SEWAGE DISPOSAL SYSTEM
HOWARD COUNTY HEALTH DEPARTMENT
BUREAU OF ENVIRONMENTAL HEALTH
410-313-2640

SUBDIVISION Brantwood II LOT NUMBER 16 ADDRESS 3108 Argent Path

<p>Date: October 13, 2014</p> <p>Name of Evaluator: Jon Blevins Time: 9:00am Property Address: 3108 Argent Path Ellicott City, MD 21042 Recent Weather Conditions: Rain</p>	<p>Ordered By: Lourdes Deppmeier</p> <p>Buyer: Lourdes Deppmeier</p> <p>Homeowner Interview: Homeowner interview was requested but not returned prior to the evaluation.</p>	<p>Occupied: <input checked="" type="checkbox"/> Yes <input type="checkbox"/> No Length of Time Vacant: N/A # of People Living in Home: 2 # of people moving in: 4 Property Age: 2001 System Age: 2001 Last Date of Cleaning: Unknown Recomm'd Pumping Freq: 3-4 Years</p>
<p>Liquid level in tank is: <input type="checkbox"/> Above Normal <input checked="" type="checkbox"/> Normal <input type="checkbox"/> Below Normal</p>	<p>Bottom Solids Depth: 10 Inches</p>	
<p>Maintenance appears: <input type="checkbox"/> Good <input checked="" type="checkbox"/> Fair <input type="checkbox"/> Poor</p>	<p>Depth of tank access: At Grade</p>

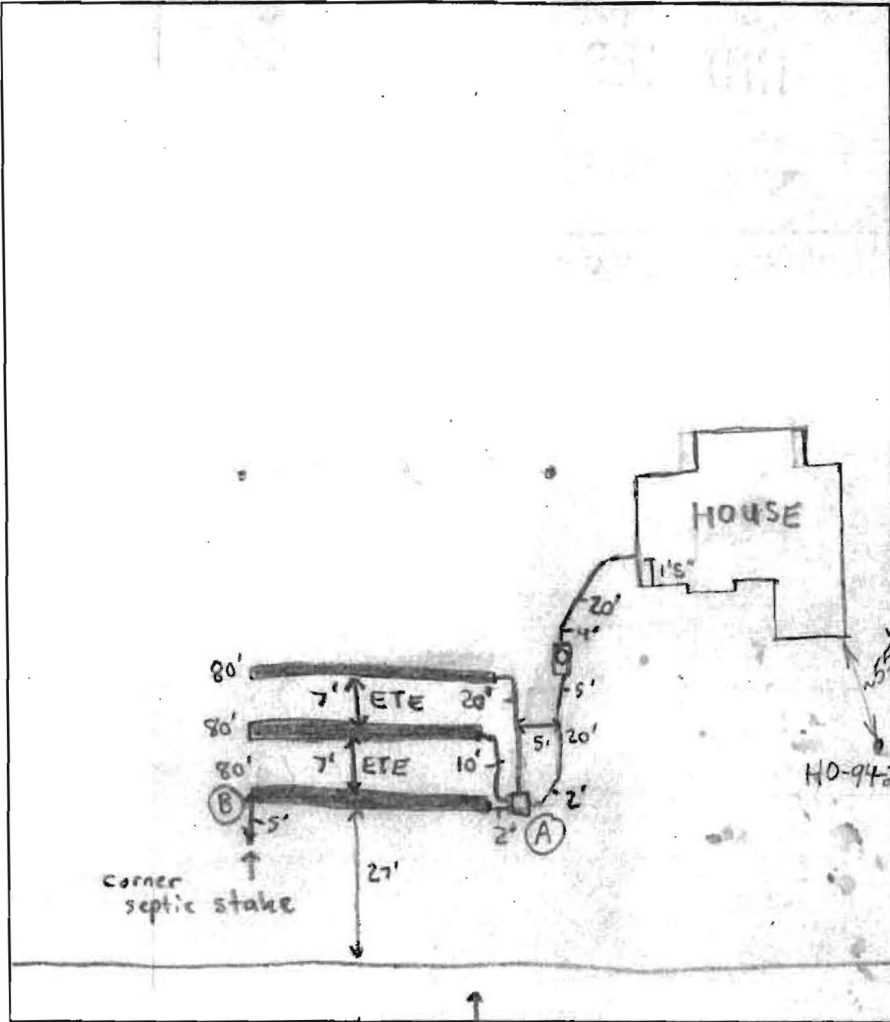
PRE-CONSTRUCTION INSPECTION: 4/16/01 System to be installed as per BP plan. Septic tank to be outside of well radius. (BB)

INSPECTION COMMENTS: 4/18/01 - CONTOUR ALTERED DUE TO (1-2') OF FILL & GRADING -

SO INSTALL DBOX IN LOCATION (A) AND RUN 3-80' TRENCHES TOWARDS LEFT LOT LINE, (INLET ON AT 4' BOTTOM AT 6') TOWARDS (B) (SRW) 4/20/01 - SYSTEM COMPLETE PENDING HOUSE CONN (SRW)

5/8/01 FINAL INSP - OG TO COVER ALL WORK. House connection confirmed. DIC

Sketch of System

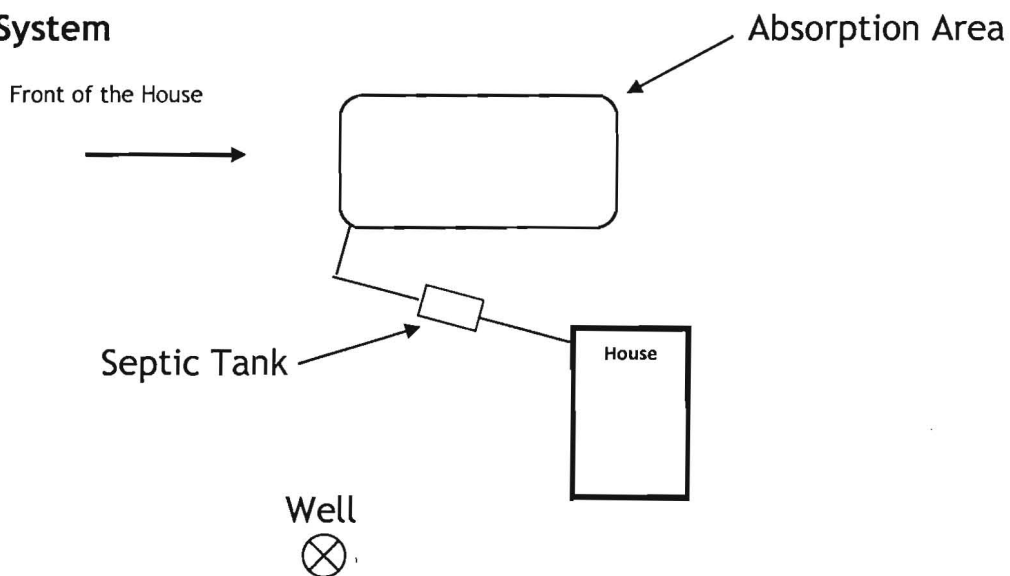
System Component	Condition	Comments
Septic Tank	<input checked="" type="checkbox"/> Acceptable <input type="checkbox"/> Unacceptable <input type="checkbox"/> Needs Further Evaluation	The two-chamber concrete septic tank is 2,000 gallons in capacity. Both front and back baffles are on the first chamber are in place and composed of PVC and concrete, respectively. The back baffle in the second chamber could not be viewed due to no access. A manhole riser serves as access at grade to the first chamber; the septic tank is 24 inches below grade. There are 10 inches of solids, and foreign objects in the tank, indicating it is due for a cleaning. The placement of the back baffle should be verified by the pumper. It is recommended that access to the second chamber be brought to grade for proper maintenance.
Pump Present? <input type="checkbox"/> Yes <input checked="" type="checkbox"/> No	<input type="checkbox"/> Acceptable <input type="checkbox"/> Unacceptable

Absorption System	<input checked="" type="checkbox"/> Acceptable <input type="checkbox"/> Unacceptable <input type="checkbox"/> Needs Further Evaluation	The absorption system is composed of trenches, which are at least 3 feet below grade. The side yard beyond the septic tank was probed and found to be dry with no signs of biomat present. Approximately 150 gallons of water were introduced into the system with no sign of a back-up.
